Addendum No. 2

(CITY OF KINGSVILLE BID NO. 25-10)
2024 GENERATOR FOR PUMPHOUSE
AT WATER WELL NO. 14

2024 GENERATOR FOR PUMP HOUSE AT WATER WELL #14
FEMA PROJECT NO. 0041

OVERALL SITE PLAN AND GENERAL NOTES

SITE PLAN - PROP IMPROVEMENTS
SCALE: 1:20

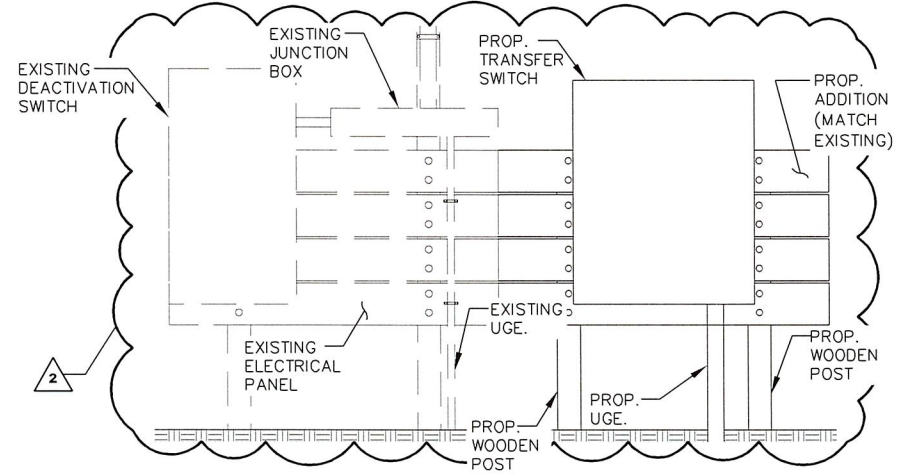
- o Sheet 2- Automatic transfer switch has been included in the Site Plan. Added Electrical Panel Detail. Concrete Slab Detail has been updated.
- IV. Questions concerning this Addendum No. 2 should be addressed to City Engineer, Rutilio P. Mora, Jr., P.E. via email to rmora@cityofkingsville.com.
